Video Products Technical Bulletin 30-2005-042

SUBJECT: REUSE IC101 WHEN REPLACING THE A BOARD

MODEL: **PVM-20M2E**
PVM-20M2U

Figure 1

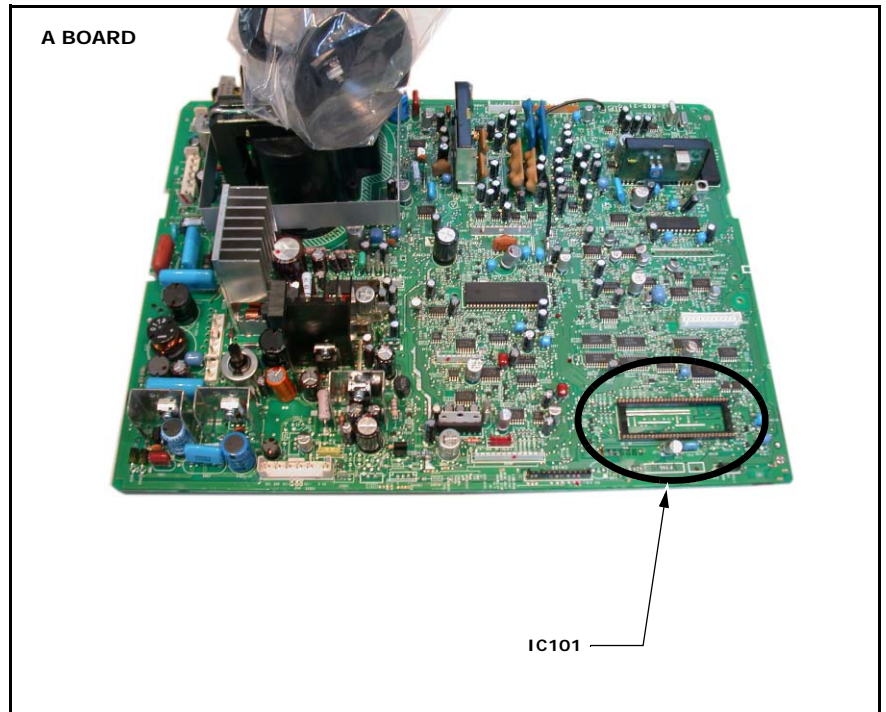
The new A board does not contain IC101, and IC101 is no longer available as a service part. (See Figure 1.)

When you replace the A board (A-1298-560-A), remove IC101 (IC UPD78014FYCW-W42, 6-802-004-01) from the former board and install it on the new board.
